VILLAGE OF ORLAND PARK

Tuesday, April 16, 2019

Plan Commission

[2018-0619](#) Tommy's Car Wash - Development Petition for Site Plan, Landscape Plan, Elevations, Special Use Permit Amendment with Modifications

1 LANDSCAPE PLAN
SCALE: 1" = 20'-0"

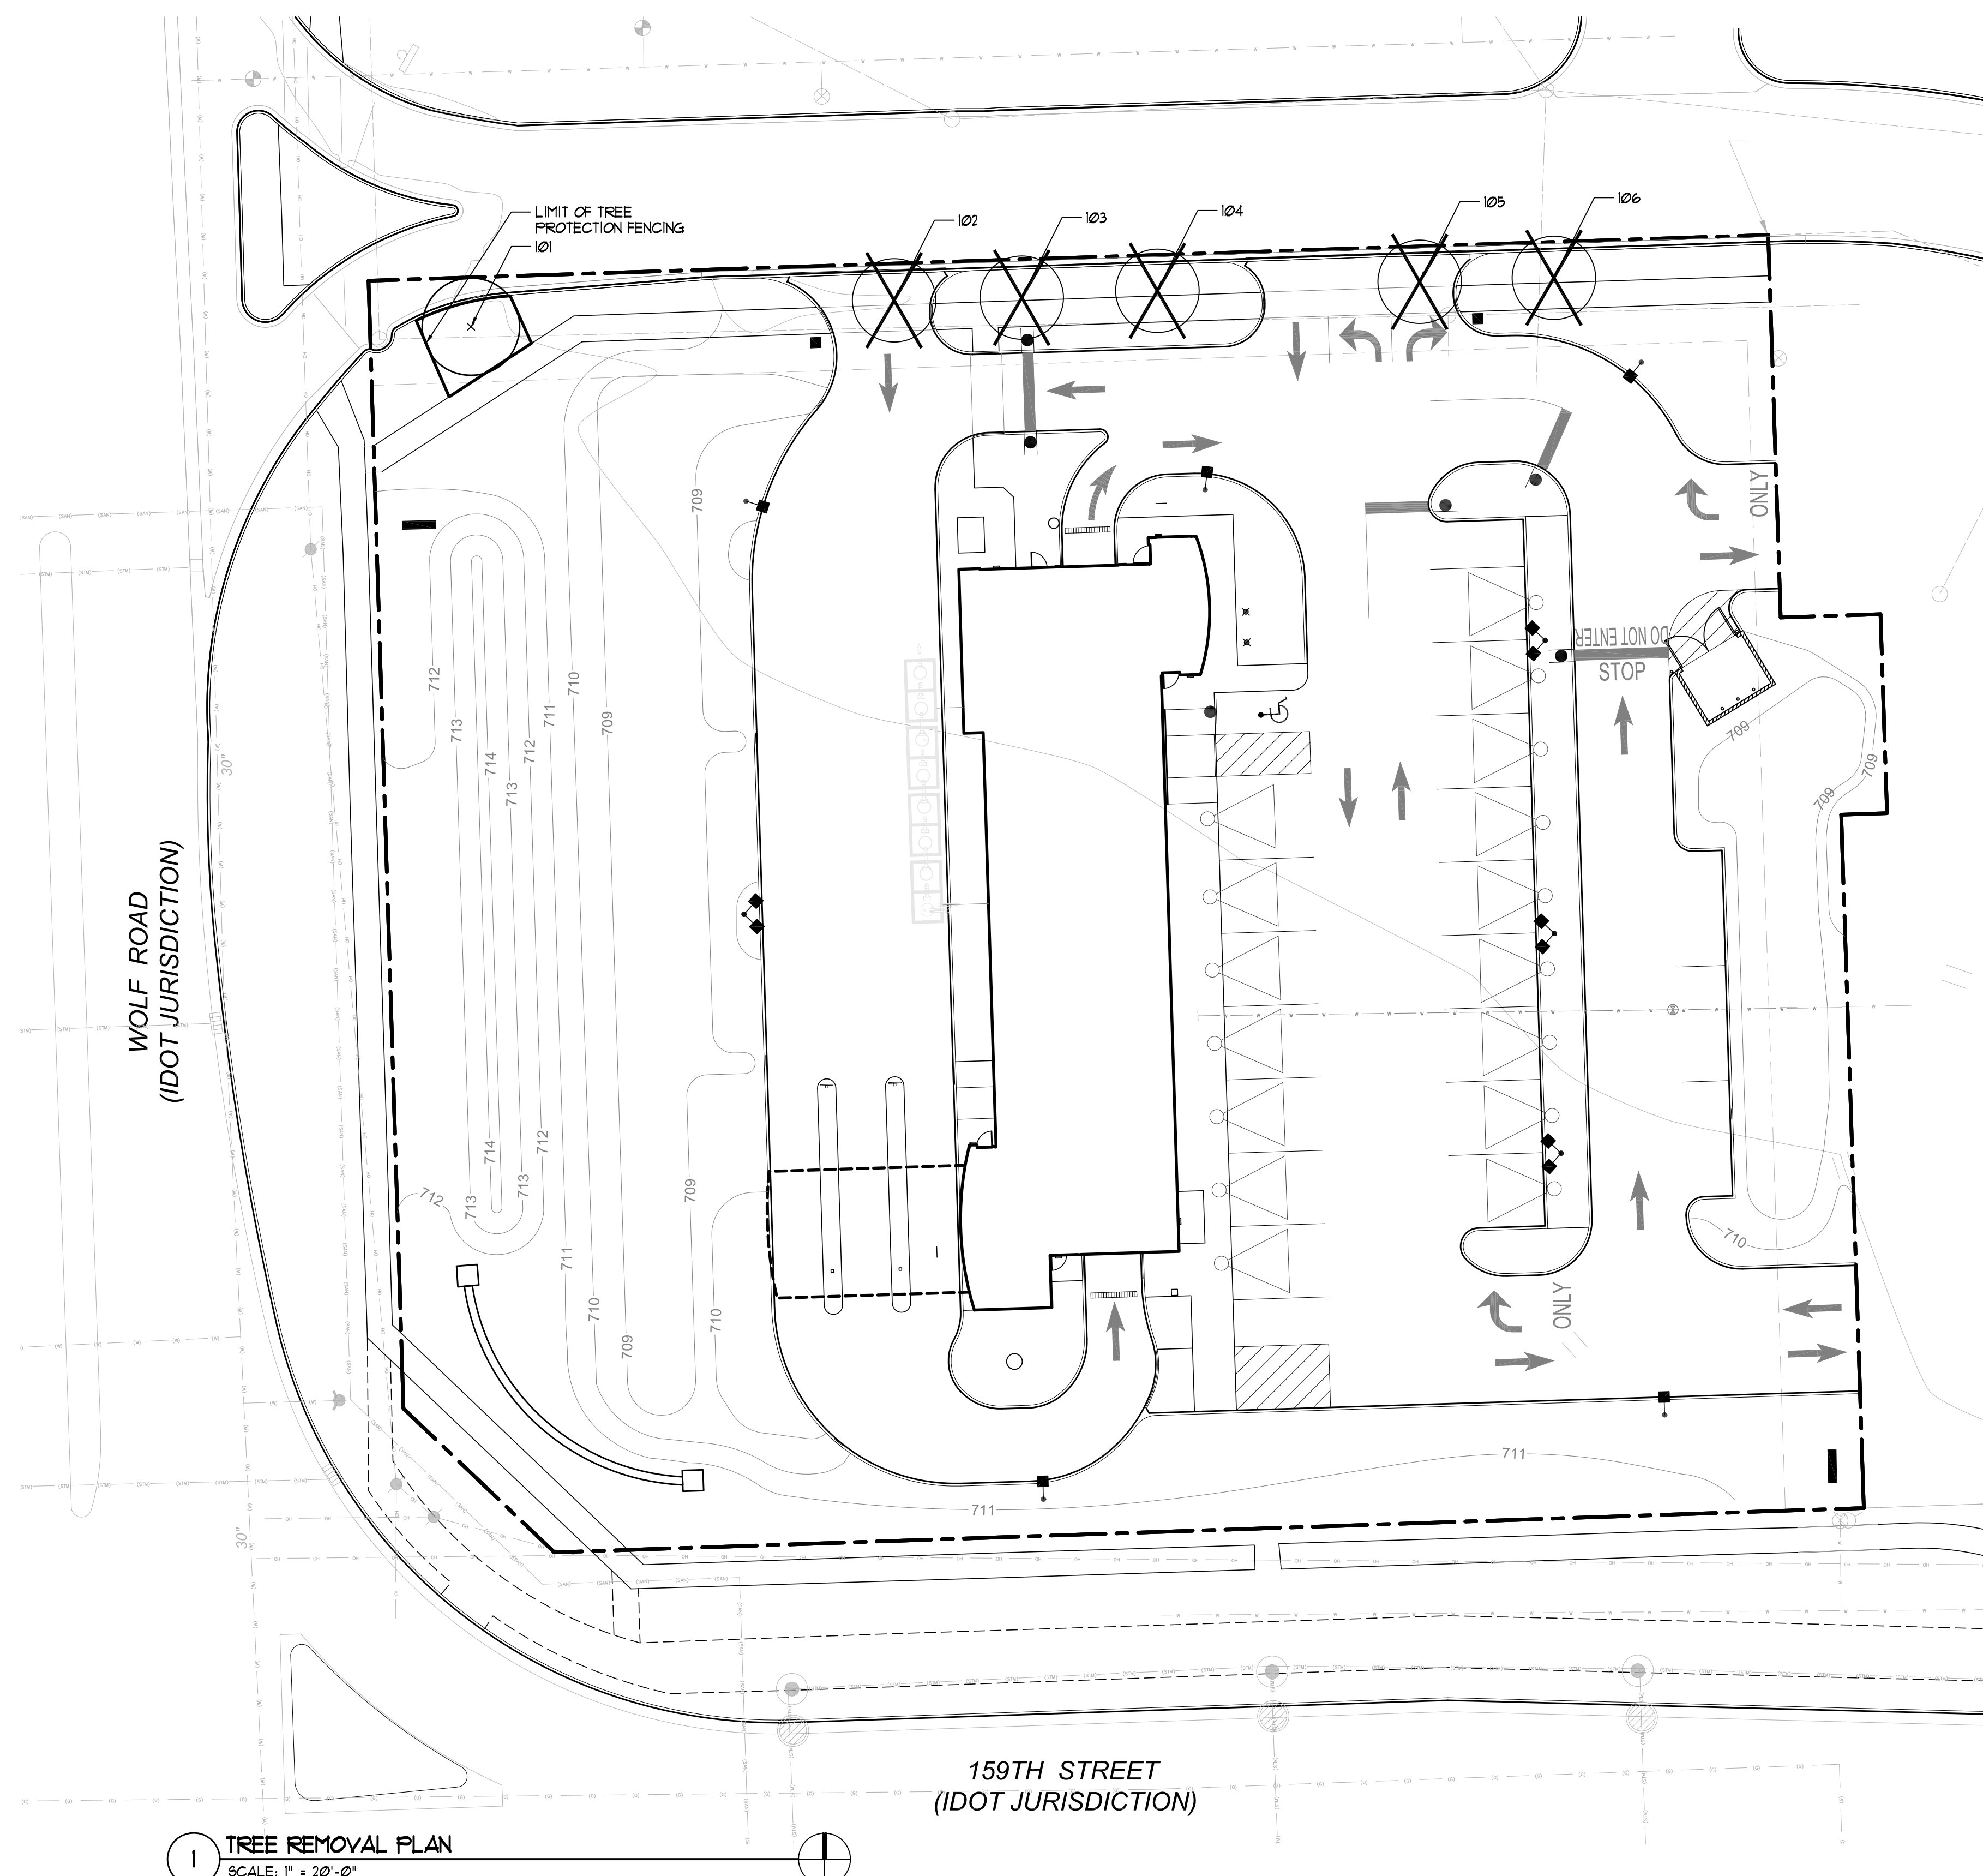
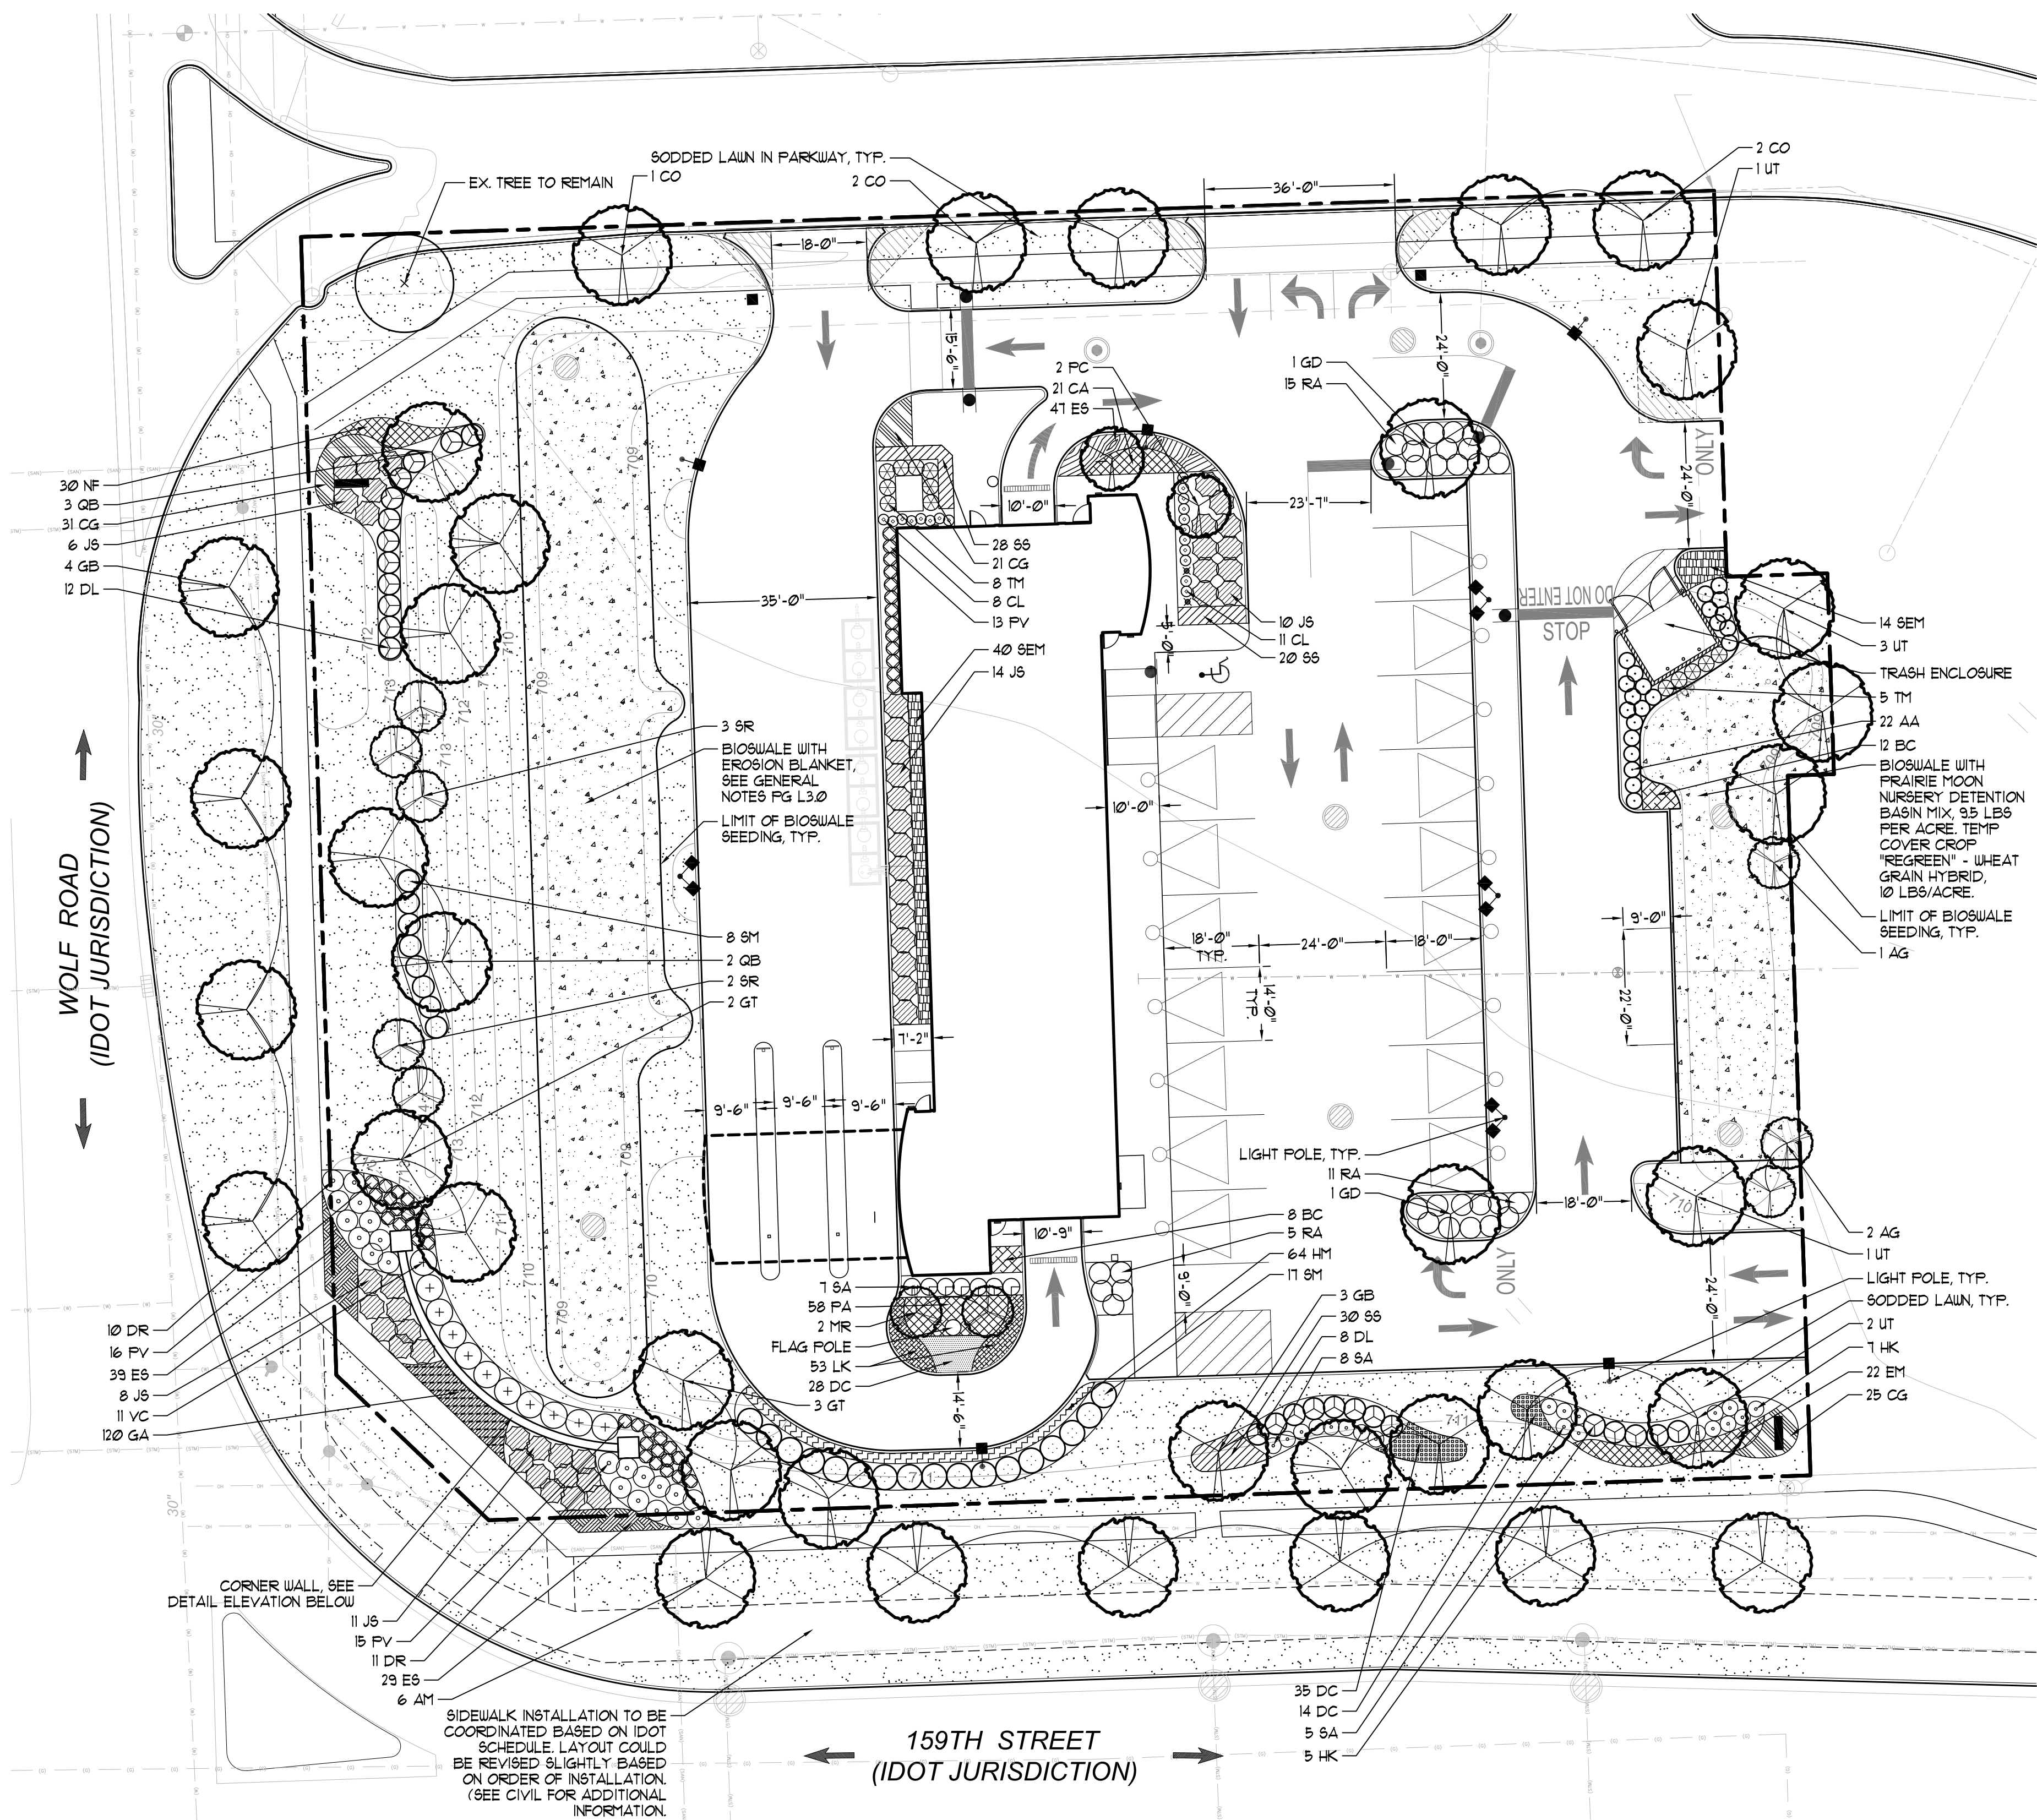
A small bioswale is also proposed along the east side of the site. Stormwater Management Area Landscape must be revised to meet the requirements of Section 6-305.D.8. A monitoring and management (M&M) plan will be required at the time of final landscape review.

I move to recommend to the Village Board of Trustees approval of the **Preliminary Landscape Plan**, titled "Landscape Plan", Sheet L.1-0, L-2.0, L-3.0, dated February 12, 2019, and "Wall Elevation", Sheet LSK-1, dated February 8, 2019, prepared by Daniel Weinbach & Partners, Ltd., with the following conditions:

1. Submit a final landscape plan meeting all Village Codes and all required supporting documentation addressing all outstanding landscape items in conjunction with the final engineering submittal.
